Statewide Utilities C&S CASE Team Comments on the Draft 2016 Title 24 Res Compliance Manual

Comments on Draft Title 24 Residential Compliance Manual

2016 CALIFORNIA BUILDING ENERGY EFFICIENCY STANDARDS

California Utilities Statewide Codes and Standards Team

Figure 4-1. Raised Heel Truss (Energy Truss)

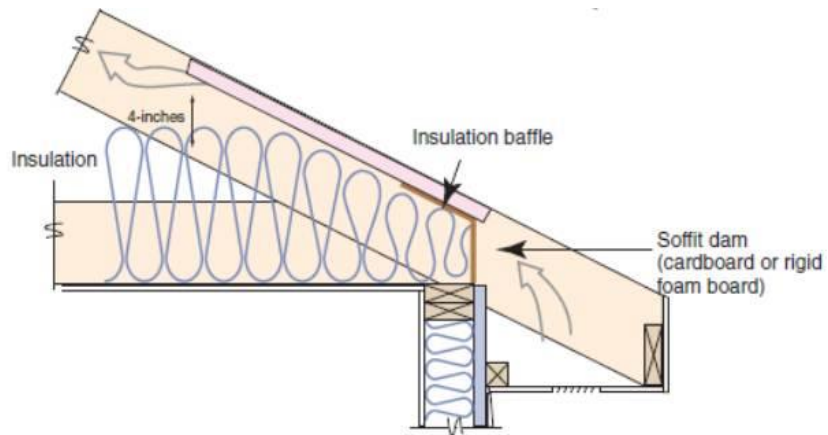
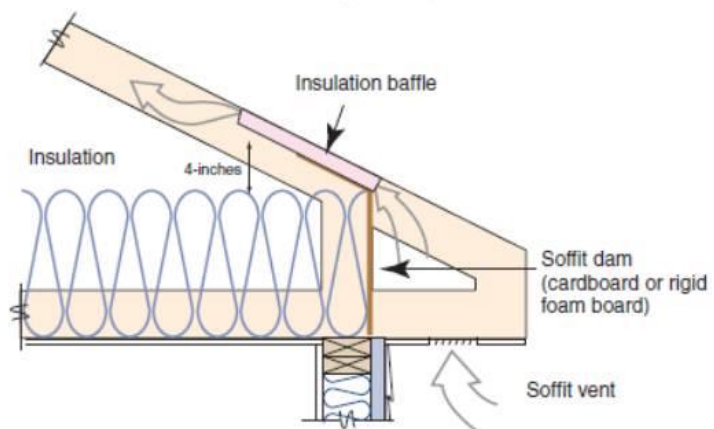
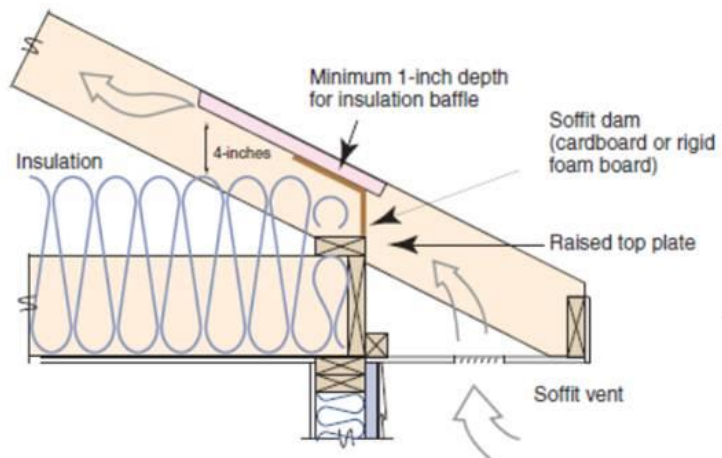
Page	Paragraph/Section	Suggested Revision	Comments
		assembly insulation is applied directly at the roofline of the building, either above or below the structural roof sheathing. The roof system becomes part of the insulated building enclosure. For this case, the thermal boundary of the building results in a non unconditioned attic space between the ceiling gypboard and the insulated roof above.	
3-103	Figure 3-36	Delete Figure 3-36.	It shows insulation at the ceiling level as well as at the roof deck. The figure does not illustrate anything mentioned in the undeleted text and contradicts the preceding text.
3-108	3.6.3.1-C: Figure 3-40	Figure 3-40 Raised Heel Truss (Energy Truss) Source: Building America Solutions Center <u>Georgia Department of Community Affairs</u>	Incorrect source is currently cited. Although retrieved from DOE Building America Solutions Center, original source of images is GA Dept. of Community Affairs.

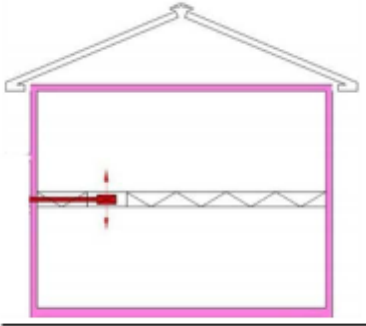
4-46	Figure 4-9	Figure 4- 8 <u>9</u> Checklist for Prescriptive Requirement - Option C DCS (§ 150.1(c).1)	This checklist refers to “Figure 4-9 Checklist for Prescriptive Requirements – Option C DCS” but the caption below the figure refers to Figure 4-8. Please clarify which one is correct.
4-46	Figure 4-9, 1 st sentence	The checklist in Figure 4-9 lists all the prescriptive <u>DCS</u> requirements that must be met in order to meet prescriptive requirements using DCS strategy.	Suggest revising to say “DCS” rather than “roof/ceiling” since there are not only roof/ceiling requirements, but also other requirements, such as: R6 or R8 ducts and verified ducts in conditioned space.
4-47	4.4.2.1.1, 3 rd sentence	Sometimes soffit spaces for duct runs are turned into room ceiling design features that change a flat ceiling into a tiered	This statement is confusing and unnecessary since there is no example
